**RECORD OF DECISION**

**Silver Bow Creek/Butte Area NPL Site  
Warm Springs Ponds Operable Unit  
Upper Clark Fork River Basin, Montana**

**United States Environmental Protection Agency**

**September 1990**

**FIGURE 3**  
**CONCEPTUAL MODEL OF**  
**CONTAMINANT MIGRATION PATHWAYS**  
**WARM SPRINGS PONDS**

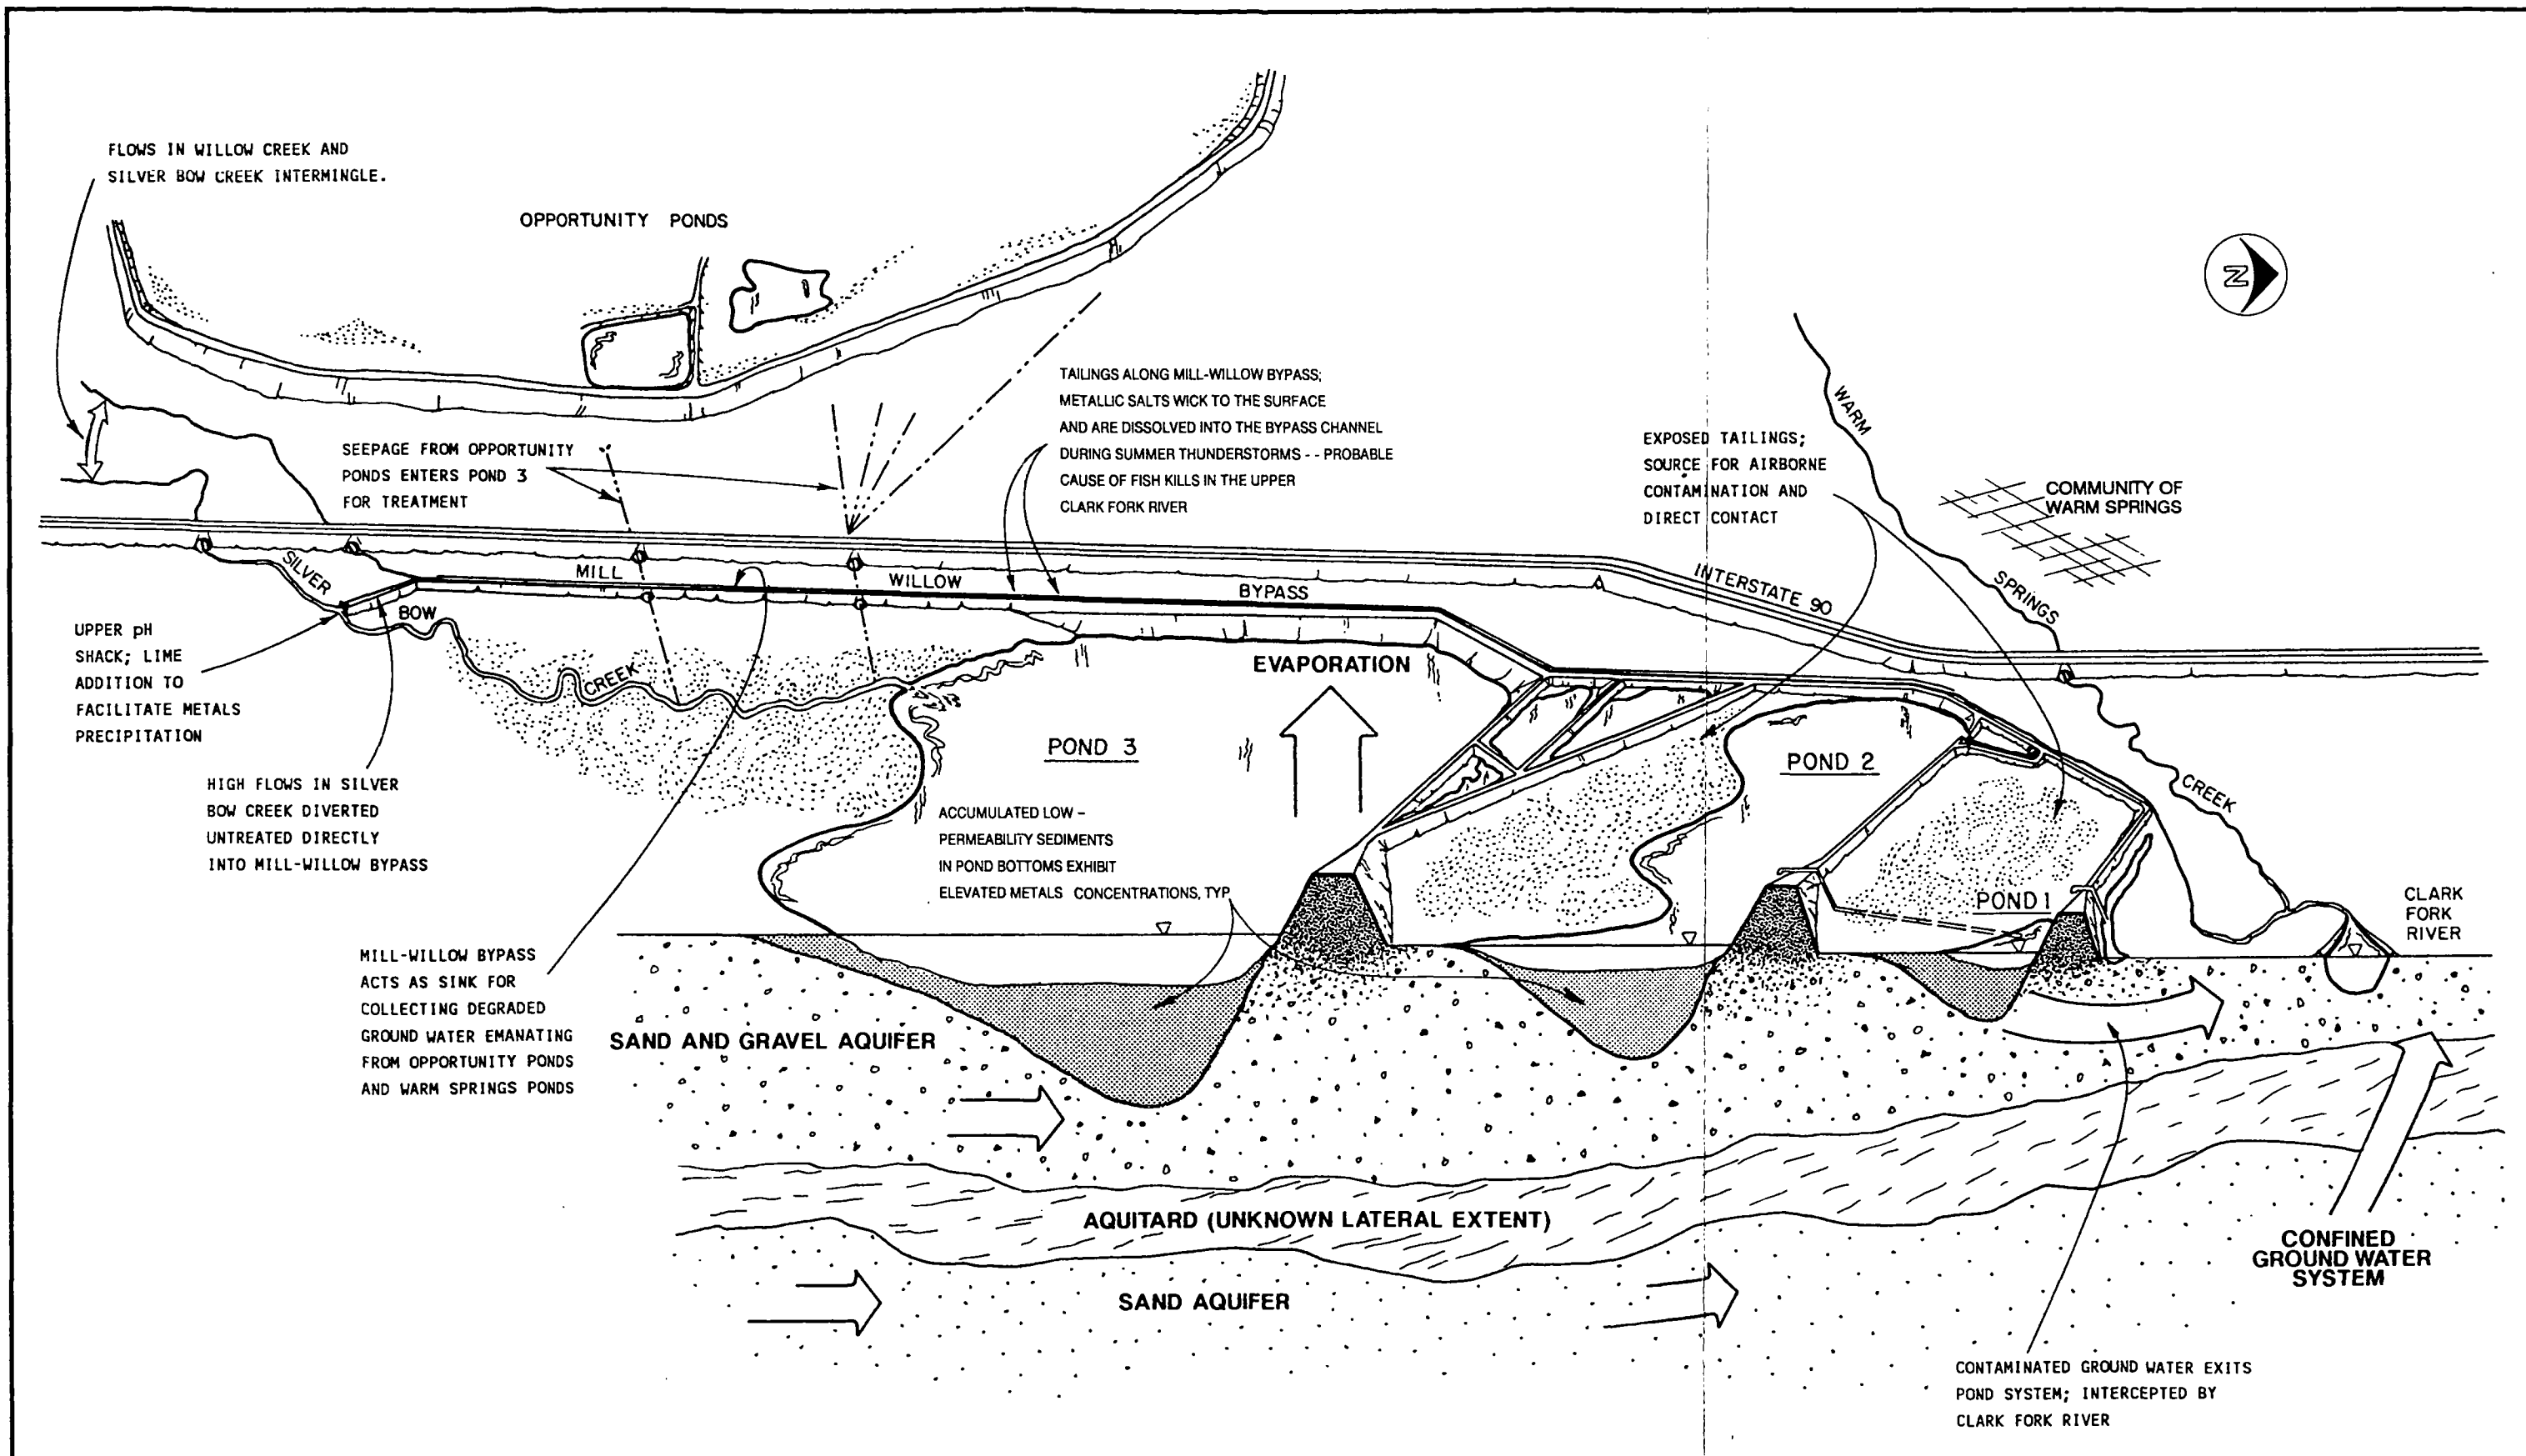
1. Comment: This comment states that Figure 2-1 should include identification of the current MPDES compliance point at Pond 2 and the Wildlife Ponds point of discharge into the Mill-Willow Bypass.

2. Comment: This comment describes Figure 2-1 "as a diagram that is used to show the areas of contamination and migration pathways associated with the four contaminated media: (1) pond bottom sediments, (2) surface water, (3) tailings deposits and contaminated soils, and (4) ground water." The comment states that Figure 2-1 is incomplete because certain deposits of tailings and contaminated soils are not shown in the figure.

Response: The intent of Figure 2-1, as indicated by its title, was to illustrate conceptually the pathways of contaminant migration within the Warm Springs Ponds Operable Unit. The surface water media and Warm Spring Ponds operation are described in detail in the surface water section of Chapter 2 (beginning on page 2-35) and in Figure 2-3.

Response: The intent of Figure 2-1 was to conceptually illustrate contaminant migration pathways at the Warm Springs Ponds Operable Unit. The figure was not intended or prepared to identify locations of all contaminant source areas within the operable unit.
